ENCLOSURE 2

**Response to NRC Request for Additional Information on
WCAP-16005-NP, Rev. 03, "San Onofre Nuclear Generating
Station Unit 2 RCS Pressure and Temperature Limits
Report"; and WCAP-16167-NP, Rev. 0, "San Onofre
Nuclear Generating Station Unit 3 RCS Pressure and
Temperature Limits Report"**

December 14, 2005

Revision 0

Figure 1: FE Models used in Computing K_{IM} due to Internal Pressure Loading

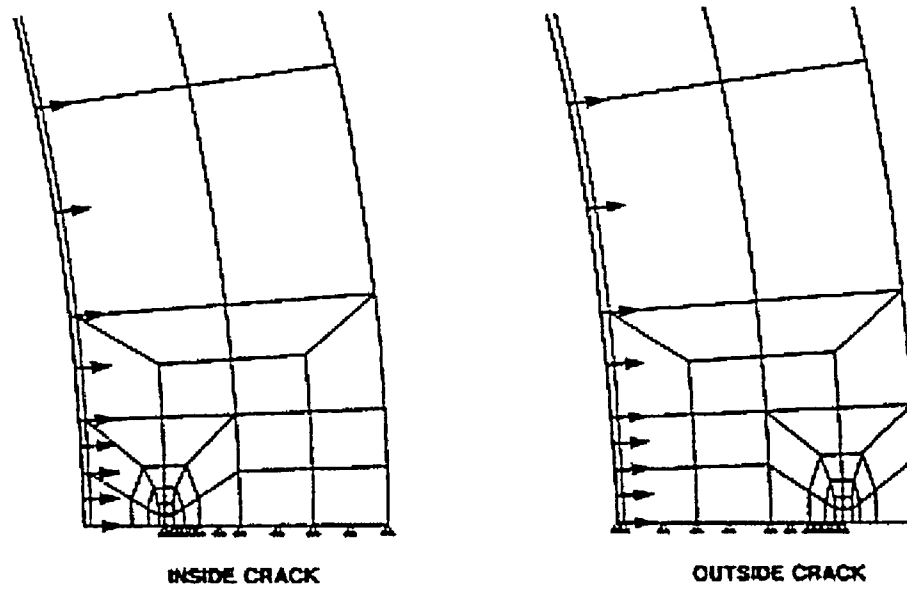
Per your response to action item 21 in RAI 1, if your methodology applies the CE NSSS method for calculating K_{IM} stress intensity values, then your application will need to include a request for an exemption from the requirements of 10 CFR Part 50, Appendix G for P-T limits. The need for an exemption for calculating P-T limits using the CE NSSS method is specified in the fourth paragraph (pages 20- 21) of Section 2.5.4 and in action item 21 (page 27) of Section 5.0 of the SE on topical report CE-NPSD-683, Revision 6, dated March 16, 2001. The CE Owners Group (CEOG) agreed to this requirement in their final version of topical report CE-NPSD-683, Revision 6. The requirement for the exemption is specified in the "Note" on page 5-15 of the topical report.

Per the conditions listed in the safety evaluation for topical report CE NPSD-683 (Reference 4) a request for exemption from the requirements of 10CFR Part 50, Appendix G, is provided in Appendix A of this document.

Figure 1: FE Models used in Computing K_{IM} due to Internal Pressure Loading

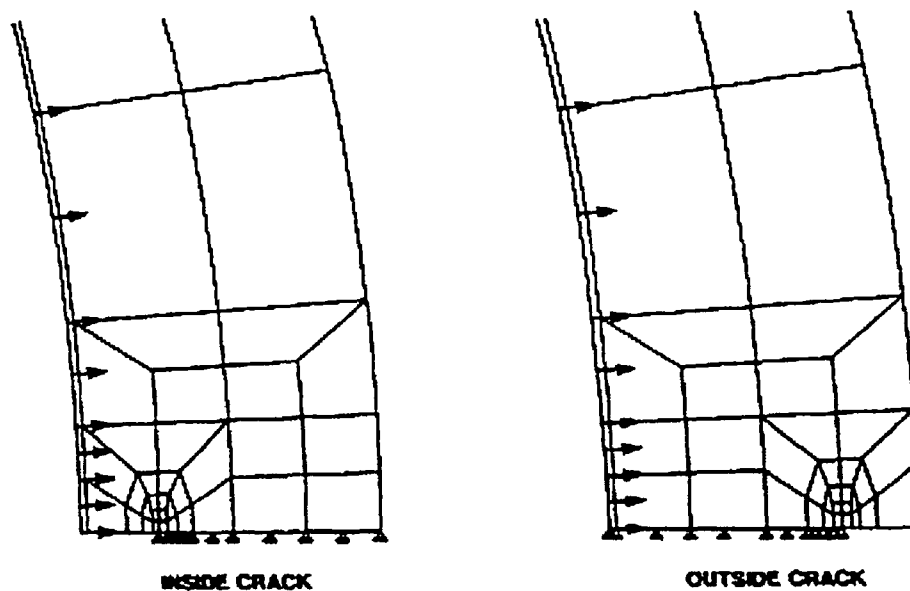
Per your response to action item 21 in RAI 1, if your methodology applies the CE NSSS method for calculating K_{IM} stress intensity values, then your application will need to include a request for an exemption from the requirements of 10 CFR Part 50, Appendix G for P-T limits. The need for an exemption for calculating P-T limits using the CE NSSS method is specified in the fourth paragraph (pages 20- 21) of Section 2.5.4 and in action item 21 (page 27) of Section 5.0 of the SE on topical report CE-NPSD-683, Revision 6, dated March 16, 2001. The CE Owners Group (CEOG) agreed to this requirement in their final version of topical report CE-NPSD-683, Revision 6. The requirement for the exemption is specified in the "Note" on page 5-15 of the topical report.

Per the conditions listed in the safety evaluation for topical report CE NPSD-683 (Reference 4) a request for exemption from the requirements of 10CFR Part 50, Appendix G, is provided in Appendix A of this document.
